# UNITED STATES PATENT AND TRADEMARK OFFICE

APPLICATION NO.	FILING DATE	FIRST NAMED INVENTOR	ATTORNEY DOCKET NO.	CONFIRMATION NO.
10/779,393	02/13/2004	Harumi Ooshima	10445/13	9011

**Office Action Summary**

Below is an enlarged section of figure 3:

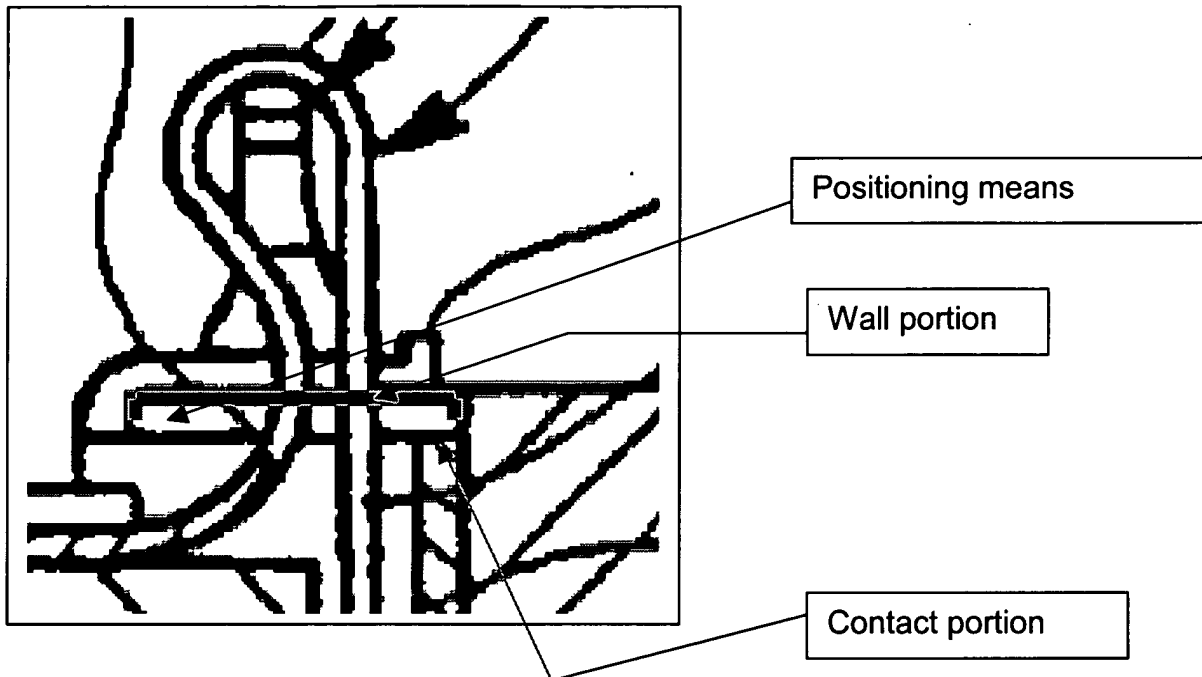
Re: claims 2, 8, and 9. Kobayashi et al. show in figures 1, 3, and 4 the limitation wherein the positioning means restrict movement of the distal end portion of the return spring by means of a wall portion (including the upper surface and side surfaces of the portion shown directly below element 13A) formed on (left surface of) the supporting member as labeled on pg. 8.

Re: claims 3, 4, 10, and 11. Kobayashi et al. show in figures 1, 3, and 4 the limitation wherein a guiding member 12 is interposed between the brake pads and the supporting member, the guiding member comprises a contact portion as labeled on pg. 8 which extends to the vicinity of the wall portion along the surface of the supporting

Re: claims 5, 6, 12, and 13. Kobayashi et al. show in figures 1, 3, and 4 the limitation wherein a guiding member 12 is interposed between the brake pads and the supporting member, and the positioning means or portion shown directly below element 13A restrict movement of the distal end portion of the return spring by means of a wall portion (particularly the left side surface of the wall portion) formed on the (upper surface of the) guiding member.
